NEBRASKA CAPITOL ENVIRONS COMMISSION

NEBRASKA CAPITOL ENVIRONS COMMISSION STAFF REPORT

APPLICATION NUMBER	Urban Design Record #24007
APPLICATION TYPE	Certificate of Appropriateness
ADDRESS/LOCATION	401 S 14 th Street and 1335 L Street
HEARING DATE	January 26, 2024
ADDITIONAL MEETINGS	December 22, 2023
APPLICANT	Lynn Rex, League of Nebraska Municipalities, lynnr@lonm.org
STAFF CONTACT	Collin Christopher, 402-441-6370, cchristopher@lincoln.ne.gov

APPLICATION NUMBER	Urban Design Record #24008
APPLICATION TYPE	Certificate of Appropriateness
ADDRESS/LOCATION	220 Centennial Mall S
HEARING DATE	January 26, 2024
ADDITIONAL MEETINGS	February 25, 2022 and July 28, 2023
APPLICANT	Drew Sova, 402-408-0005, dsova@whitelotusgroup.com
STAFF CONTACT	Collin Christopher, 402-441-6370, cchristopher@lincoln.ne.gov

ATTACHMENT B – Site Plan

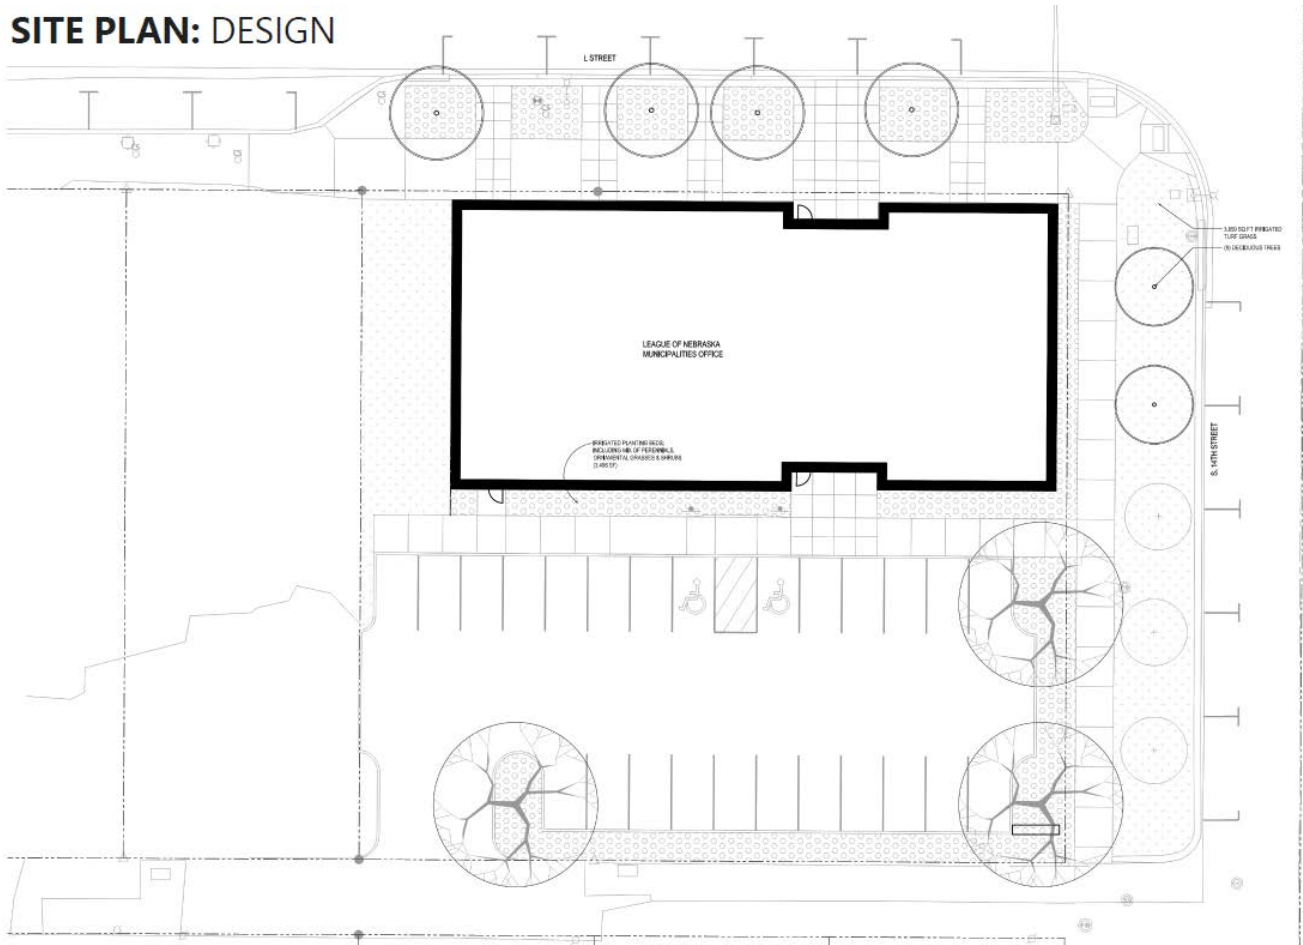
Compatibility per Staff Analysis: The proposed building appears to meet the façade requirements for this part of the district. The brick cladding and building transparency fit very well with the surrounding context of the area, offering a timeless aesthetic that should age nicely. From a site development perspective, the building holds the corner of the S 14th and L Streets intersection, with just enough of a setback to allow for footings to be constructed on private property.

Compatibility per Staff Analysis: The proposed street frontage improvements along both L and St 14th Streets do effectively meet the intent of this standards.

Compatibility per Staff Analysis: The parking in the rear is almost entirely hidden from view from the L Street side, and while it is visible from the S 14th Street side, the proposed landscape screening appears to effectively limit its impacts from the street, as well as from the alley and the adjacent property. Additionally, new street trees have been shown per the requirements of the design standards. It should be noted that the material provided by the applicant does not include a final landscape plan with specific species selection. Planning Department staff will work with Parks staff to ensure that all proposed plant species are acceptable prior to the issuance of a building permit.

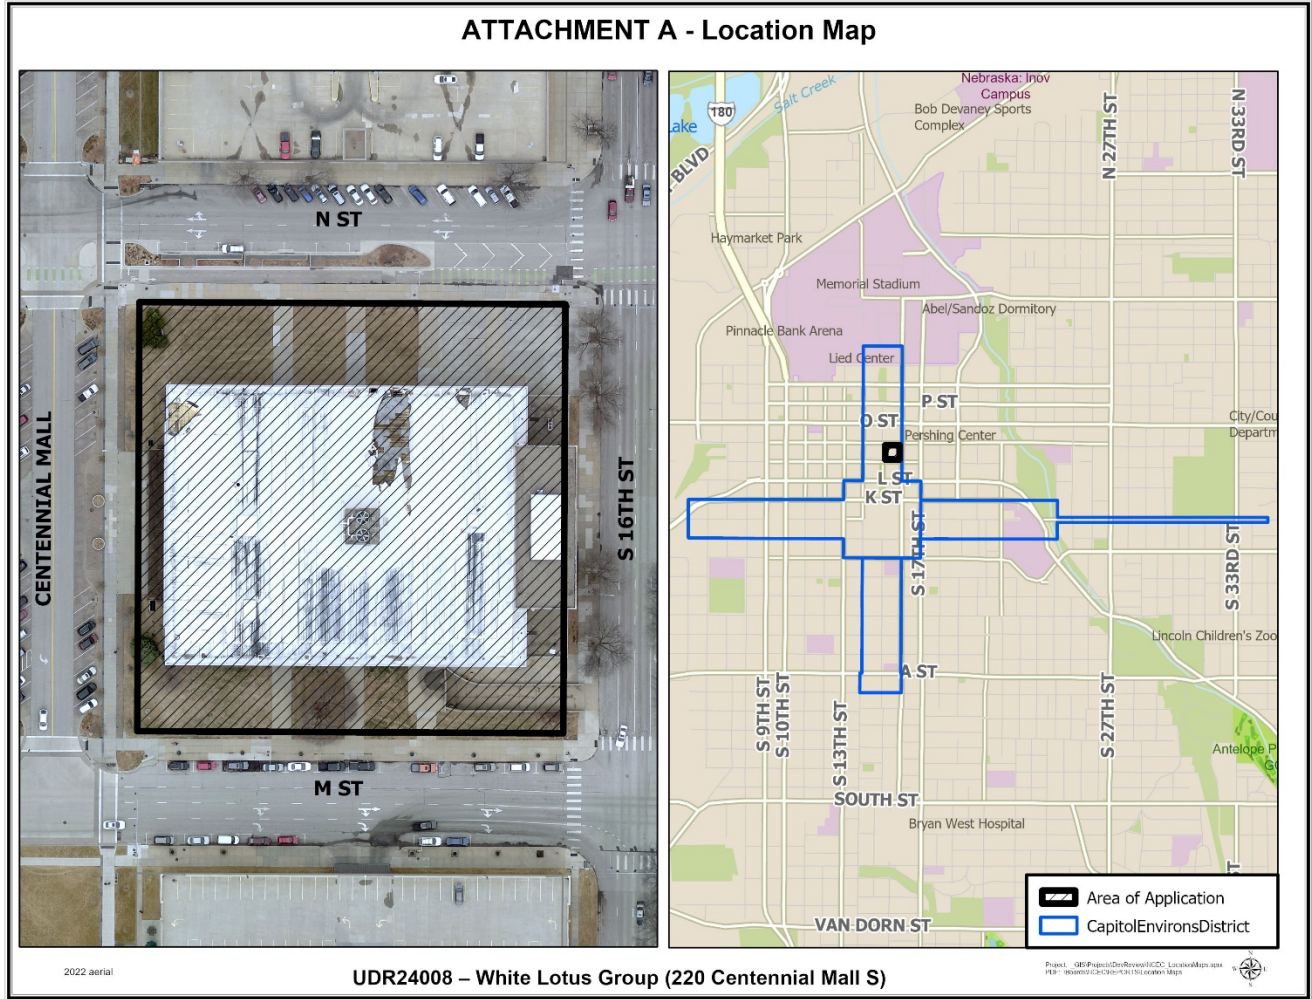
Compatibility per Staff Analysis: Though the first phase does not extend to Centennial Mall, it is important that this block feels cohesive, and the existing aesthetic of the Centennial Mall should be a driving force in that cohesion. Though proposed streetscape plans do not have all of the amenities that Centennial Mall has, the design framework established by the hardscape and landscape improvements for the first phase looks appropriate and complementary to Centennial Mall.

In general, the streetscape and rooftop and utility screening plans are in conformance with the design standards, though the Commission should offer any guidance to the applicant as it relates to material and finish concerns. While staff has some reservations about the width of useable sidewalk along S 16th Street, the streetscape design represents the best available solution that addresses both developer and city needs and is the result of much coordination and problem-solving over the last several months.
